# Access Compliance Report

## Public Rights-of-Way

### (Curb Ramps)

Intersection ID: 52100	Main Street: FRED_D_ALEXANDER_BV	Cross Street: LITTLE_ROCK_RD	Location: NW
ADA ID: 78EF29D1578F	Ramp Type: Perp	Initial Pass/Fail: Fail	Overall Compliance: No
Severity Score: 10			
Codes/Mitigation Info/Possible Solution		Field Measurements/Component Compliance

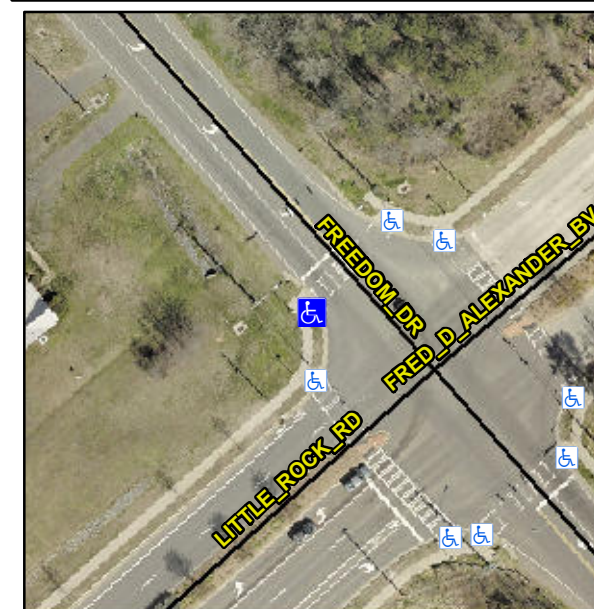
**Not Found, R304.5.1, R304.5.3**

Compliance	Description	Data	Compliance	Description	Data
N/A	Ramp Length (in)	122.0	Yes	Ramp Slope (%)	7.3
No	Ramp Width (in)	47.0	No	Ramp XSlope (%)	2.4
N/A	Flare Type LT	N/A	N/A	Flare Type RT	N/A
N/A	Flare Slope LT (%)	N/A	N/A	Flare Slope RT (%)	N/A
N/A	Flare Traversable LT?	N/A	N/A	Flare Traversable RT?	N/A
N/A	Landing Length (in)	N/A	N/A	DWS Provided?	N/A
N/A	Landing Width (in)	N/A	N/A	DWS Contrast?	N/A
N/A	Landing Slope (%)	N/A	N/A	DWS Length (in)	N/A
N/A	Landing X Slope (%)	N/A	N/A	DWS Full Width?	N/A
N/A	Landing Curb? (Y/N)	N/A	N/A	DWS Offset (in)	N/A
N/A	Shared Landing?	N/A			
N/A	Gutter Ponding?	N/A	N/A	Gutter Slope (%)	N/A
N/A	Gutter Lip Ht (in)	N/A	N/A	Gutter X Slope (%)	N/A
N/A	Painted X Walk1?	Yes	N/A	Painted X Walk2?	N/A
	X Walk 1 Direction	To NE		X Walk 2 Direction	N/A
N/A	X Walk 1 Width (in)	115.0	N/A	X Walk 2 Width (in)	N/A
	X Walk 1 Slope (%)	4.9		X Walk 2 Slope (%)	N/A
	X Walk 1 X Slope (%)	1.9		X Walk 2 X Slope (%)	N/A

**Remove & Replace Entire Ramp.**
